Comment (#167):

(TDL #385 D2.2)

**Comment: Do we need the spec for Irms in 145.3.8.4?**

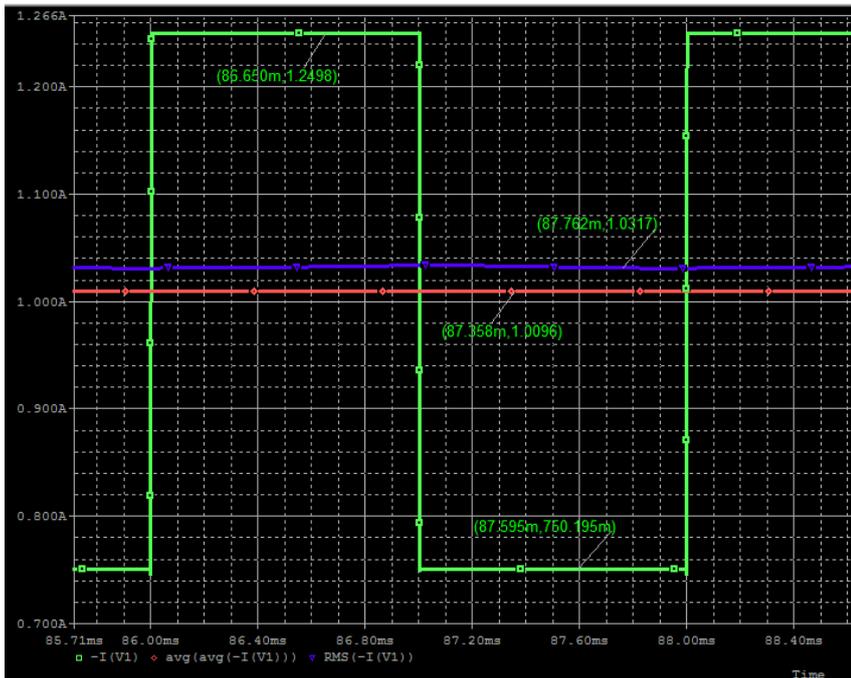
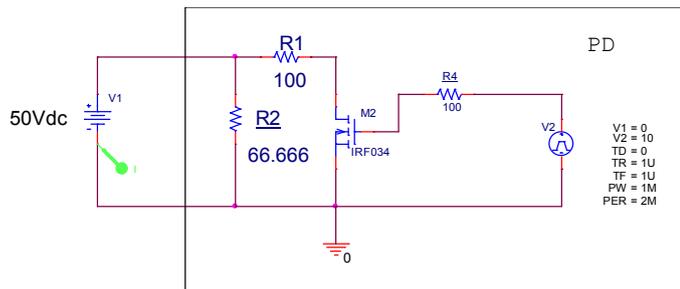
If we measure only the DC current when we test Icon or Icon-2P under overload conditions for compliance we will not know if PD is cheating or not.

PD can be designed to generate average current that will meet  $P_{class\_PD}/V_{port\_PD-2P}$  value but the actual RMS current will be higher and will cause excessive power loss on PSE. See Annex B for examples.

The ways to ensure 100% compliance are:

Measure average power in power meter that follows Equation 3) and Peak power and duty cycle timing.

RMS current may be used to verify that  $I_{rms} \leq I_{avg}$  if time segments of each load level is calculated separately as described above, and verified against with Peak Power time and duty cycle limits.
